STAFF REPORT

APPLICATION: AGENDA ITEM I.2 MARCH 28, 2024 MEETING

Re: IWWA Application: 390 Ash Swamp Road

Single Family House and Septic System

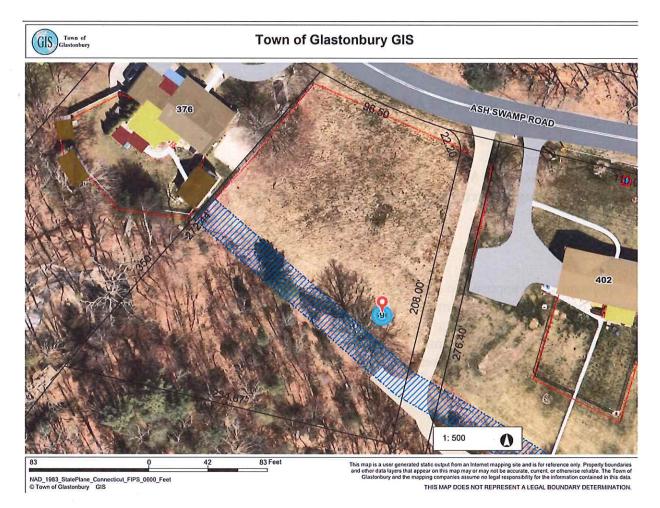
The property is approximately .92 acres within the Rural Residence Zone and Groundwater Protection Zone #1. The property is not encumbered by a conservation easement. The plan locates a watercourse bisecting the property in an east/west orientation, contained within the blue lined area in the map below. The cleared limit on the plan is consistent with the aerial map showing the area east of the brook as lacking trees.
